HISTORIC AND DESIGN REVIEW COMMISSION

October 18, 2017

HDRC CASE NO: 2017-521
COMMON NAME: RIO 7
ADDRESS: 1430 S FLORES ST
LEGAL DESCRIPTION: NCB 2566 BLK 1 LOT E 84.8 FT OF 1, 2, 3 & 4 & NCB 2566 BLK 2 LOT W IRR 37.29 FT OF 1 & W IRR 53.9 FT OF 8
ZONING: I-1
CITY COUNCIL DIST.: 5
APPLICANT: Deborah Schievelbein
OWNER: 1610 Broadway LTD
TYPE OF WORK: Exterior Modifications
REQUEST:

1430 SOUTH FLORES STREET
PROPOSED RENOVATIONS
DATE: SEPT. 28, 2017

EXISTING WEST ELEVATION OF BLDG #2
SCALE: N.T.S.

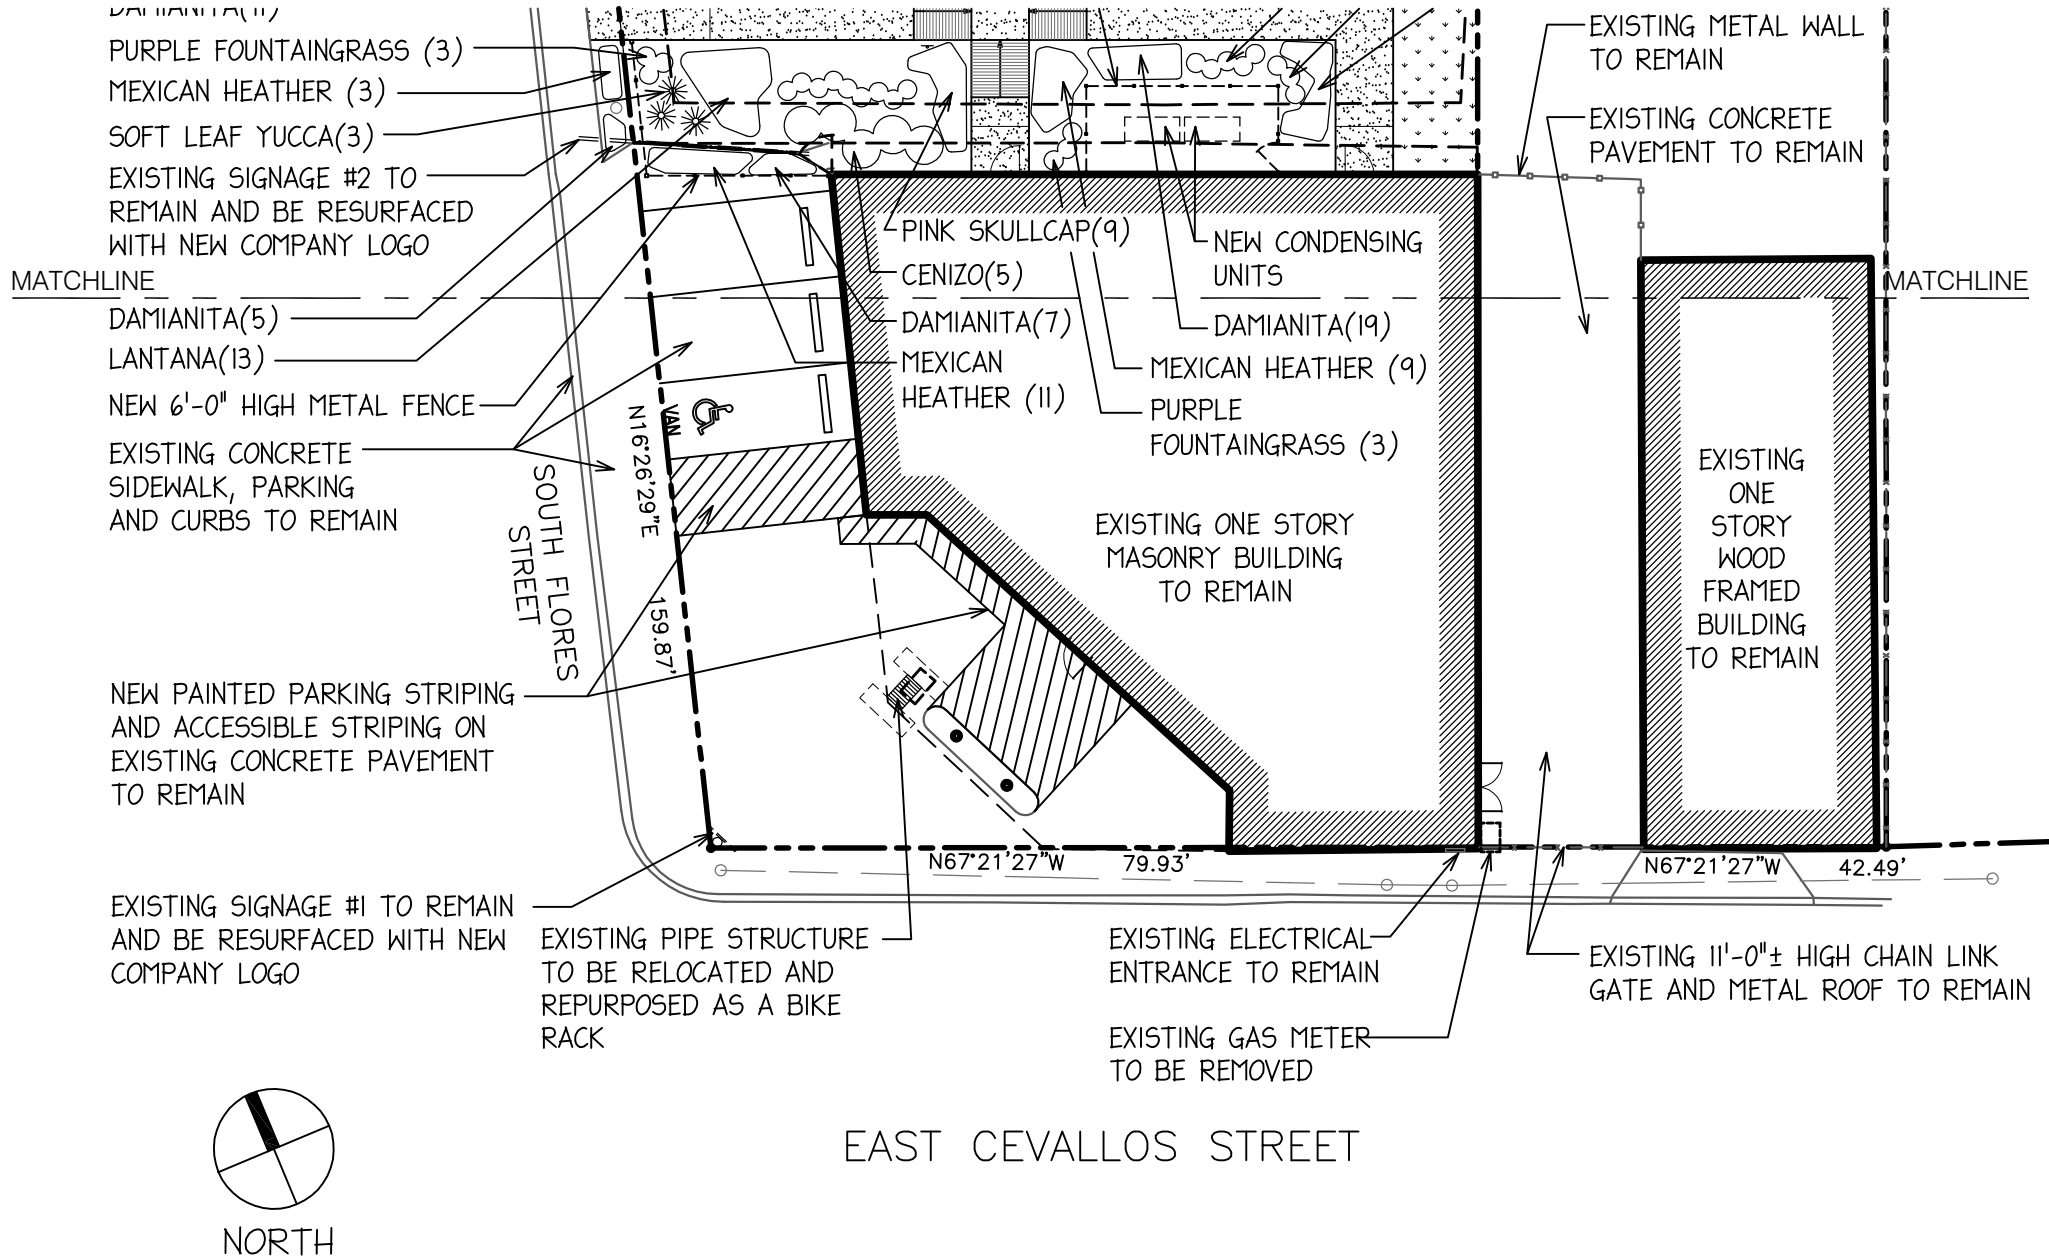
- b. **WINDOW REPLACEMENT (West Elevation)** – The applicant has proposed to replace the existing windows and doors. On the west elevation, the applicant has proposed to remove the existing windows and the framed window opening which includes a concrete canopy. The applicant has proposed to remove the existing, steel windows and install four new windows. The windows would feature a height that is consistent with the previous windows.

Staff recommends approval of item #1, window replacement with the stipulation that the proposed new windows feature a similar appearance, profile and type as the original.

PROPOSED ROOF PLAN
SCALE: 1"= 10'-0"

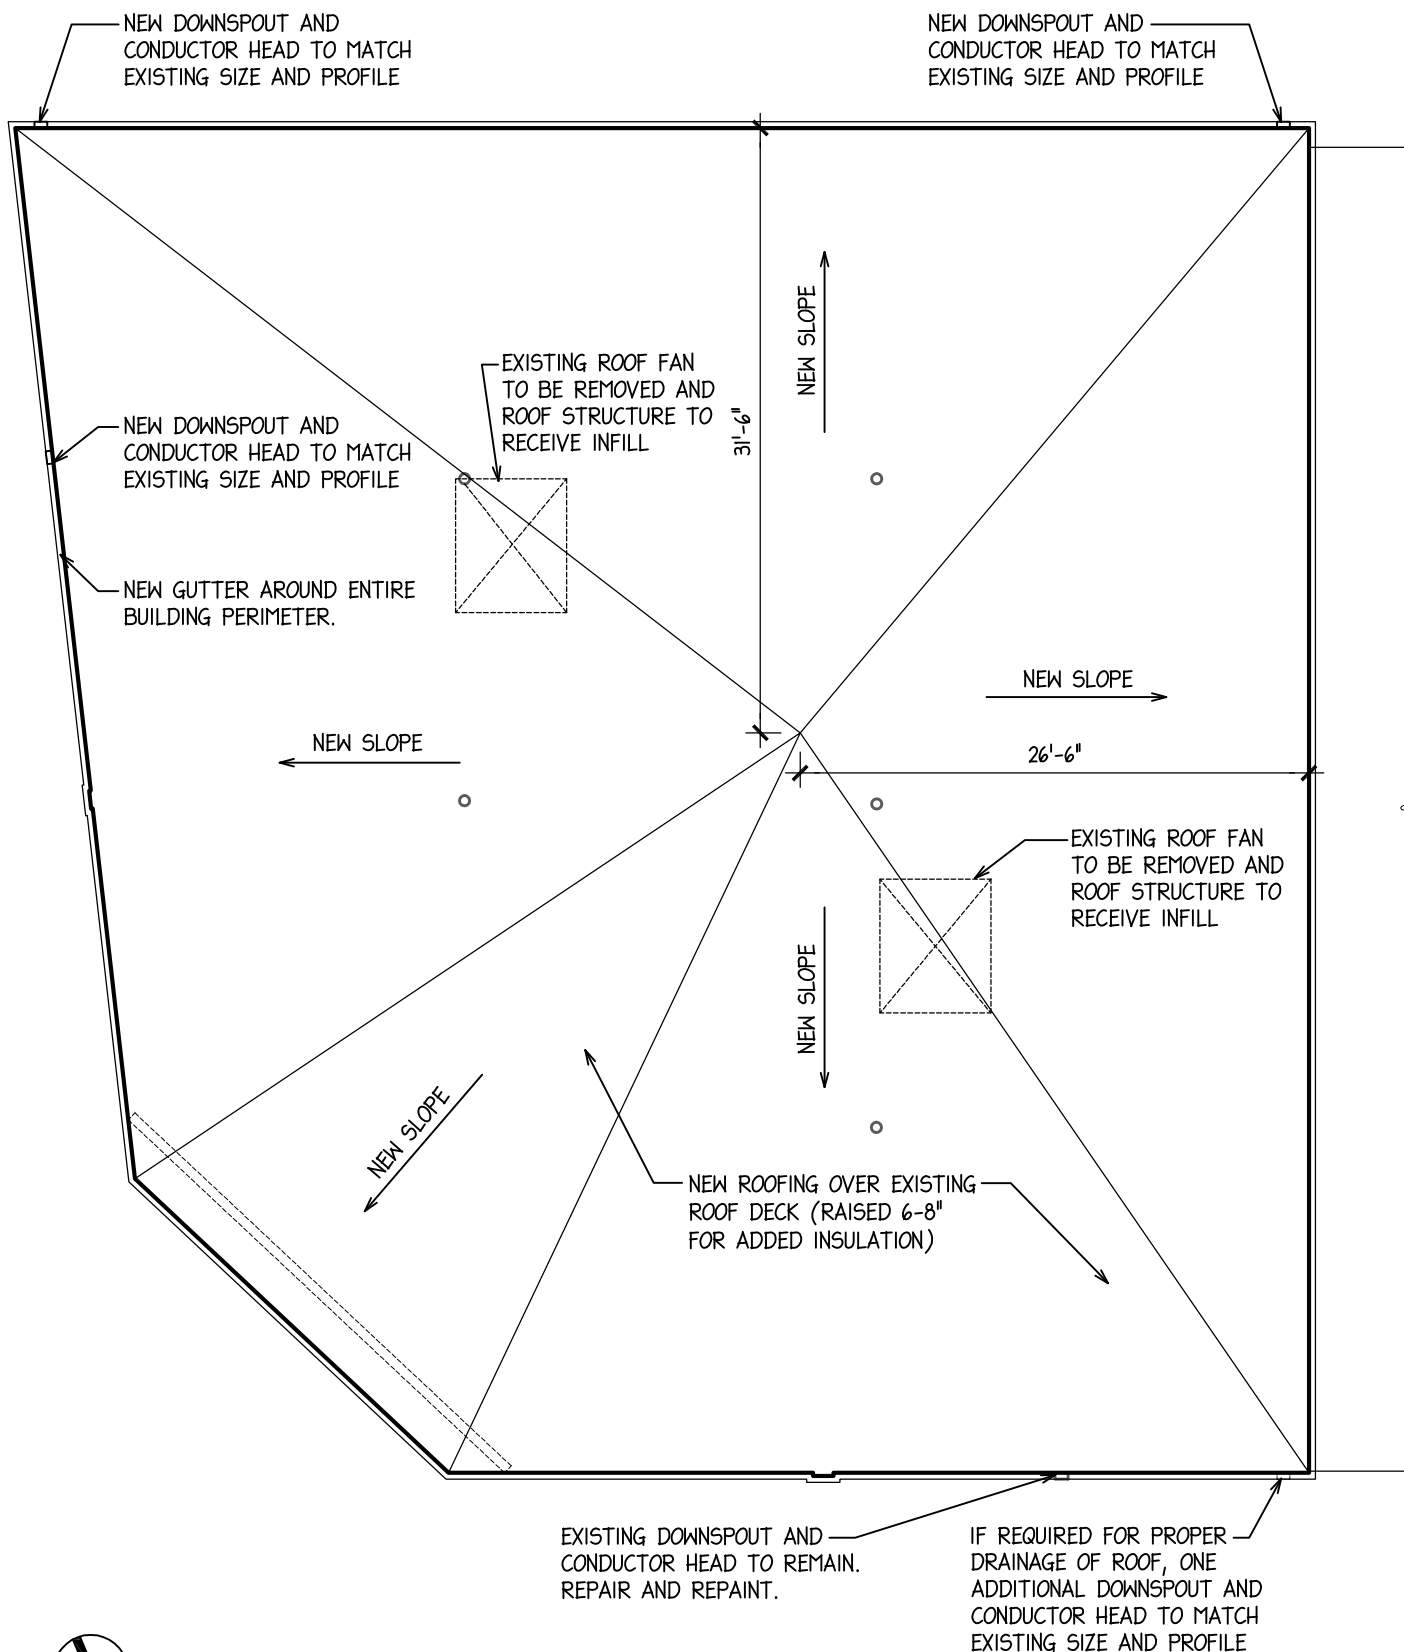
- j. **ROOFING, AWNINGS & GUTTERS** – The applicant has proposed to remove the existing roof fans and roof fan hoods, install a new roofing system above the existing roof raising the total height approximately 6 to 8 inches, install canopies above exit doors and install gutters and downspouts. Staff finds the proposed modifications to be appropriate and consistent with the UDC Section 35-676.

PROPOSED SOUTH ELEVATION

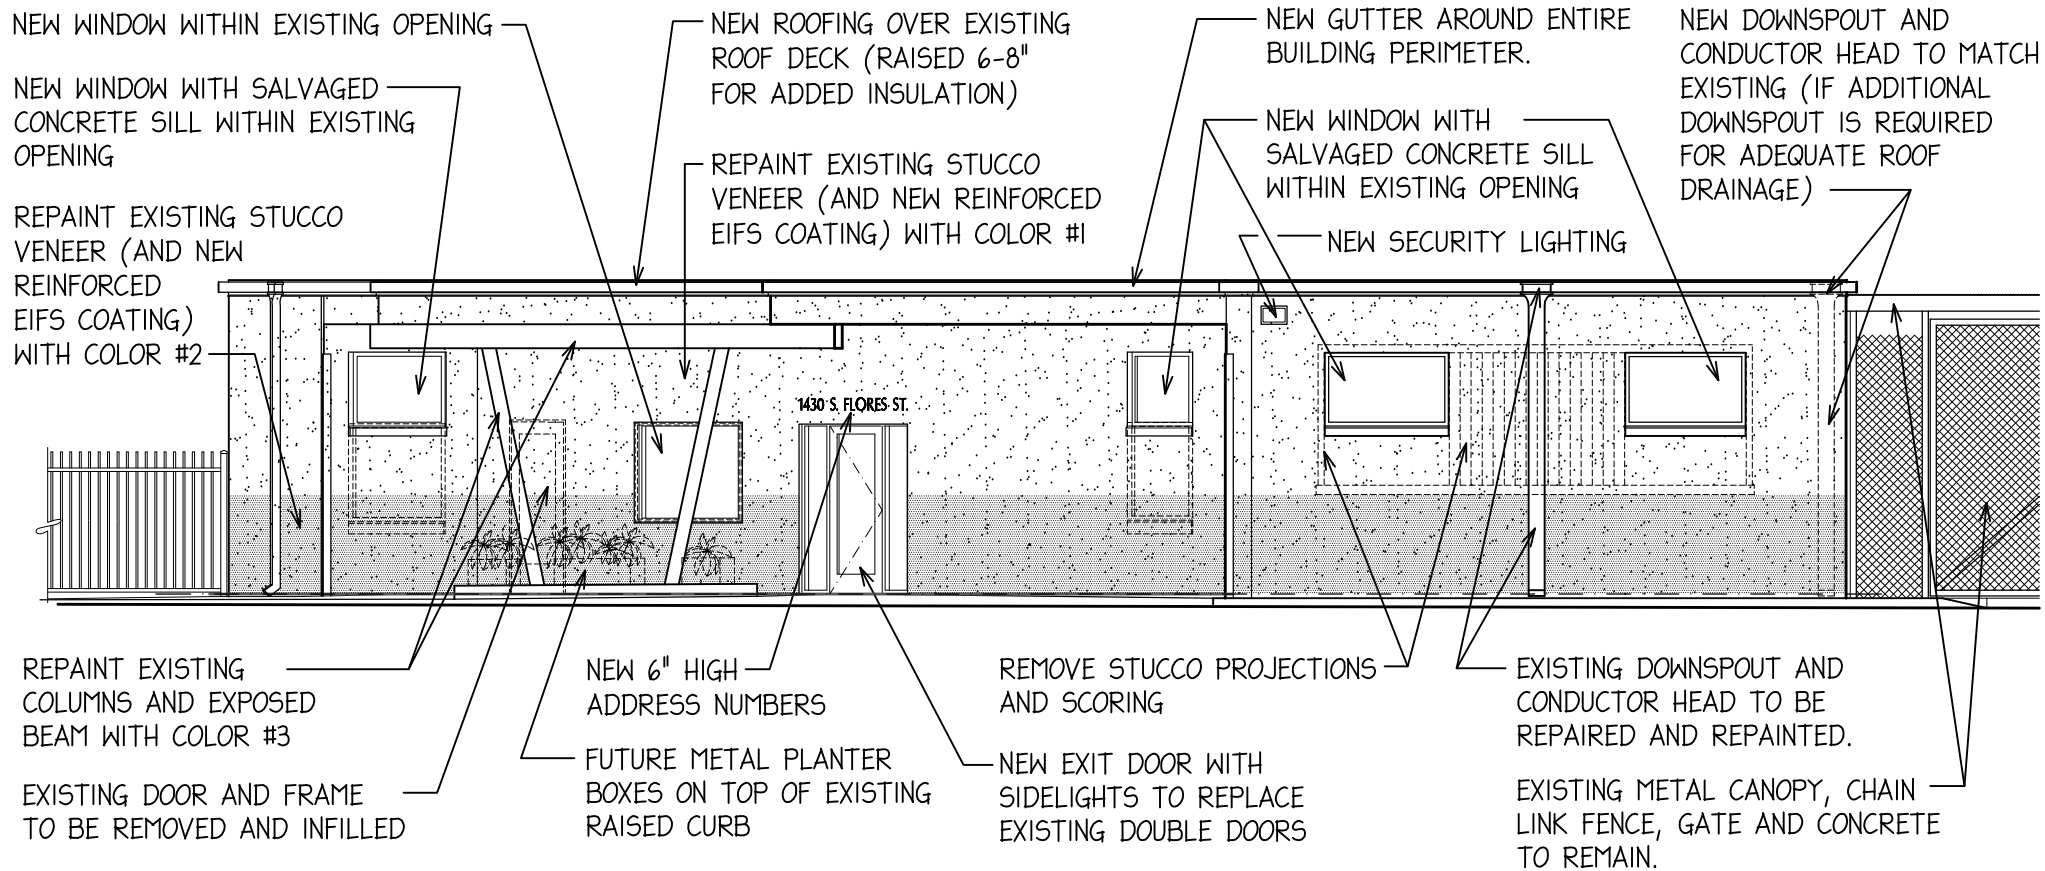
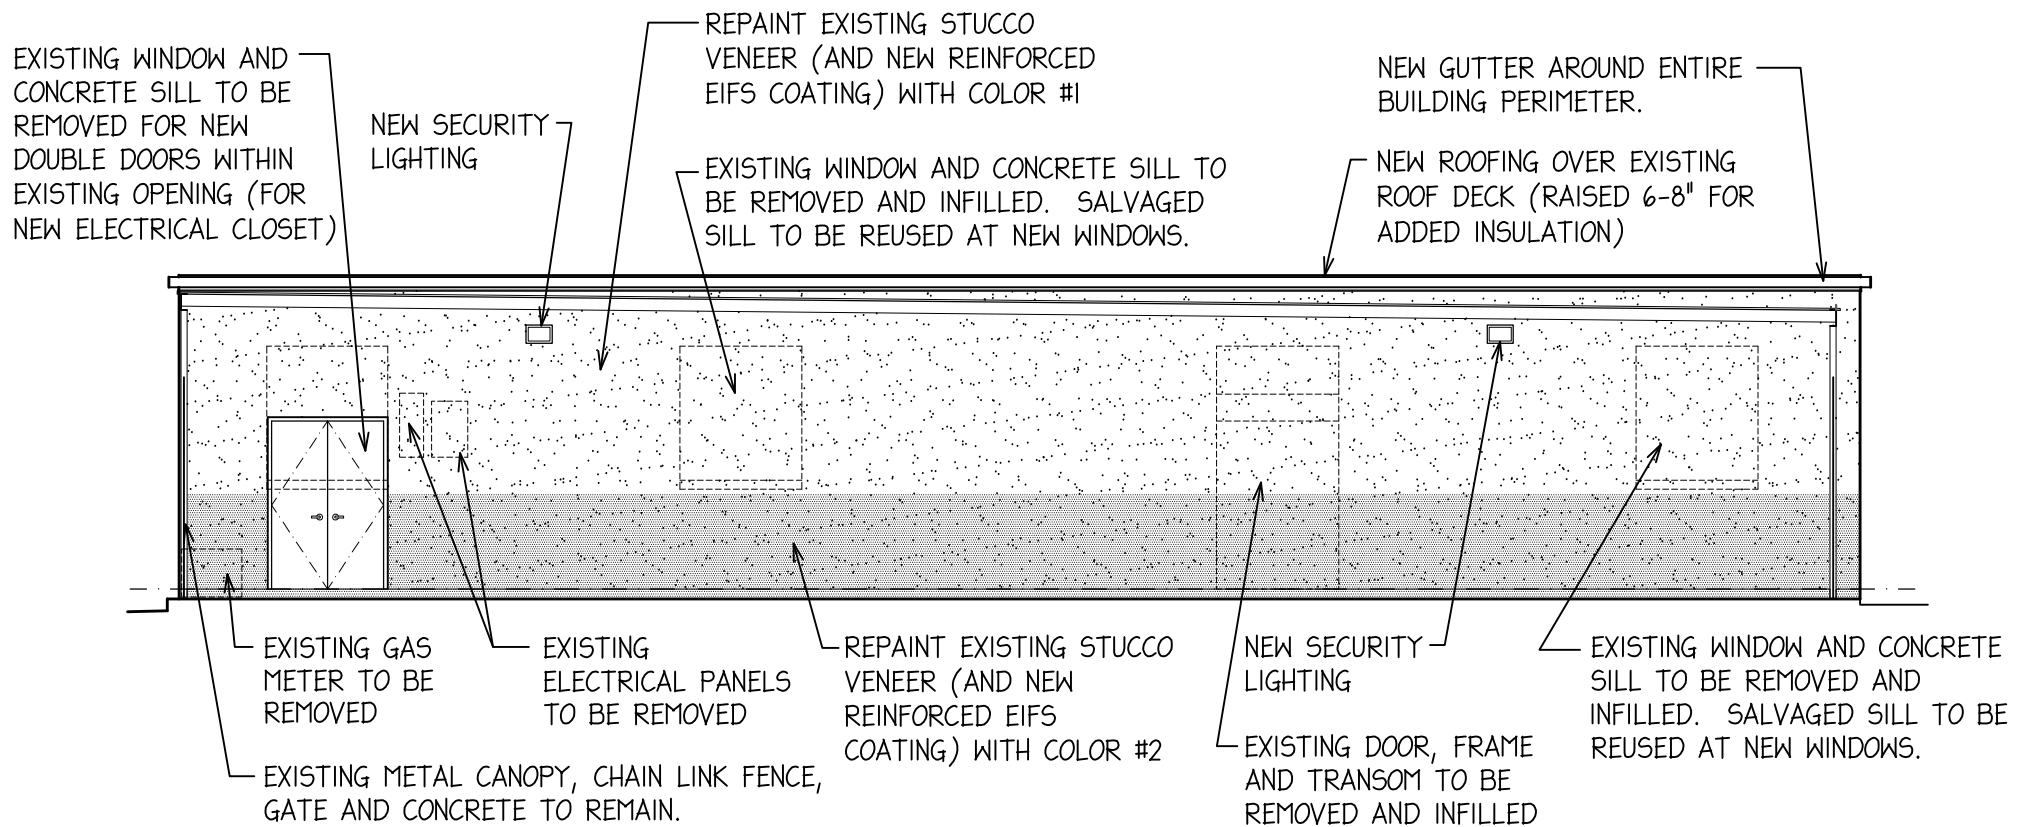
- c. **WINDOW REPLACEMENT (South Elevation, under canopy)** – The applicant has proposed to remove three existing windows and modify two of the window openings. The left two windows are fixed windows while the right window is a steel, divided lite window. The applicant has proposed for the outside two window openings to be modified in height.

- d. **WINDOW REPLACEMENT (South Elevation, Cevallos)** – The applicant has proposed to modify two original window openings and replace two original steel windows. The applicant has proposed to reduce the windows in height and between the windows, modify the original scored concrete detailing.

- i. **DOOR REPLACEMENT & MODIFICATIONS** – The applicant has proposed to replace one door on the south elevation and modify its opening to include sidelites. Also on the south façade, the applicant has proposed to remove an original door opening. On the north elevation, the applicant has proposed to install two new exit doors. On the east elevation the applicant has proposed to infill an existing door opening and transom window and install a new door at an existing window opening. Staff finds the proposed modifications to door openings to be appropriate. The proposed new door and sidelites should remain the same width as the existing door opening.

- i. The existing window canopy on the west elevation as well a scored wall detailing on the south elevation should remain.
- ii. The proposed new door and sidelites on the south elevation should remain the same width as the existing door opening.

EXISTING EAST ELEVATION

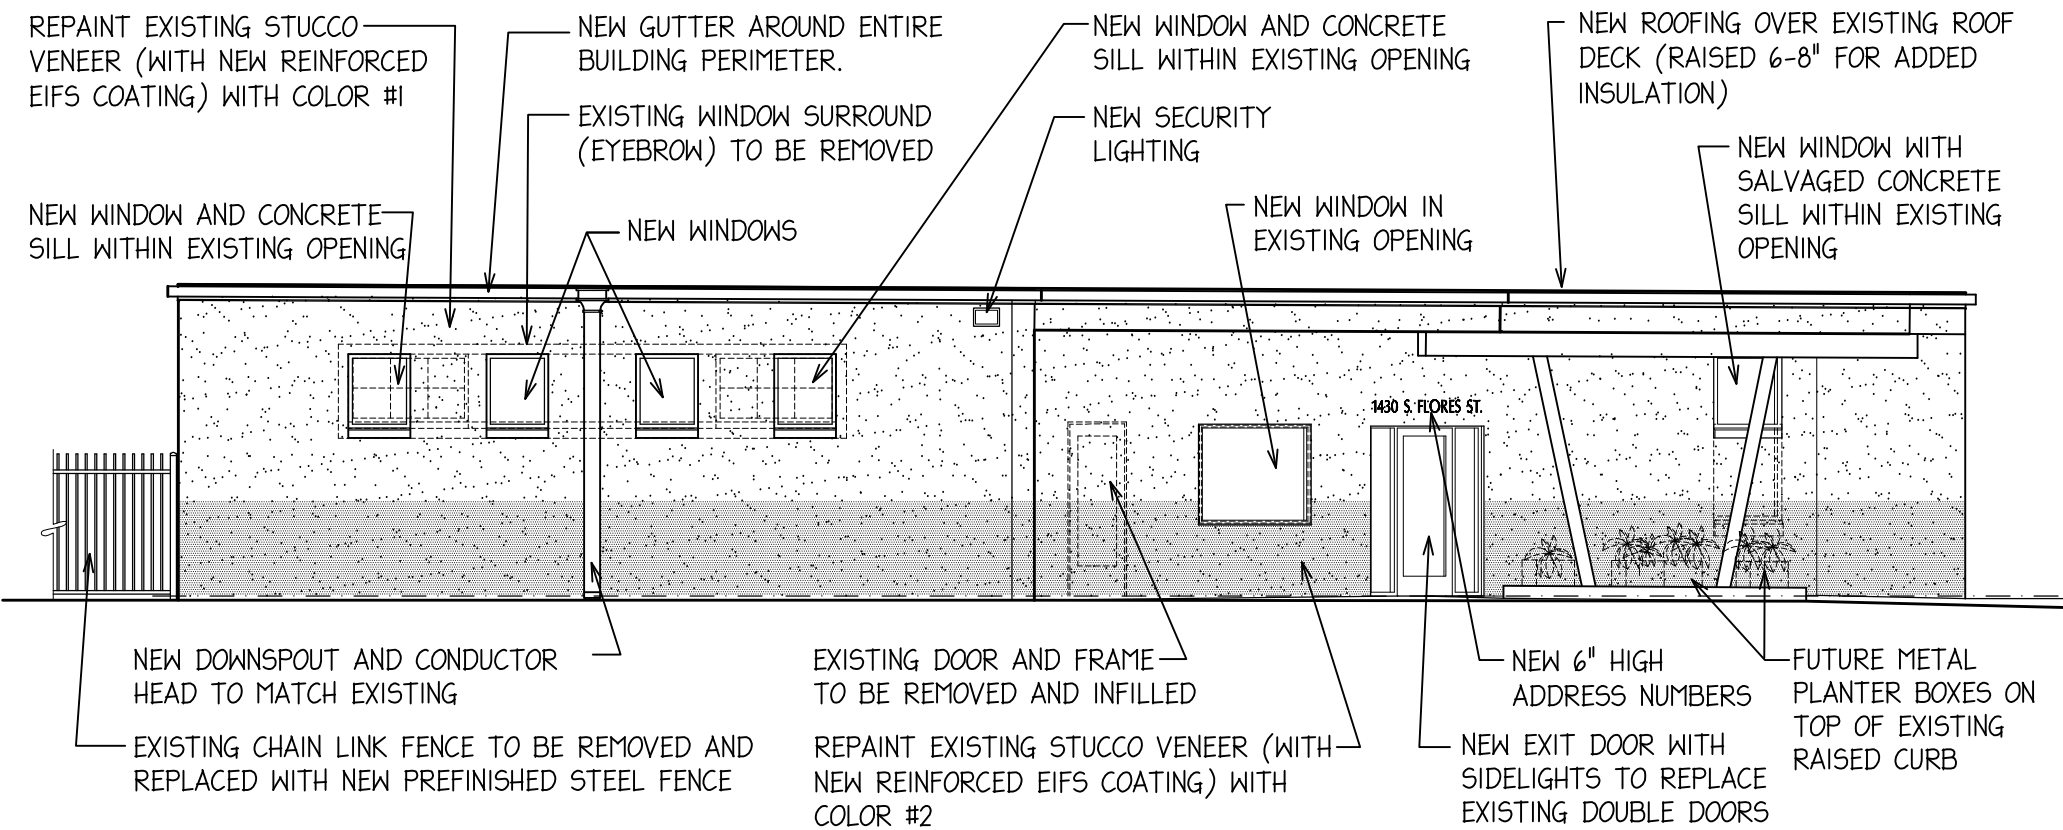
- f. **WINDOW REMOVAL (East Elevation)** – The applicant has proposed to remove three original window openings on the east elevation. The southernmost window opening will become the location of a proposed door opening. Staff finds this proposed door installation appropriate given that it maintains the width of the original opening.
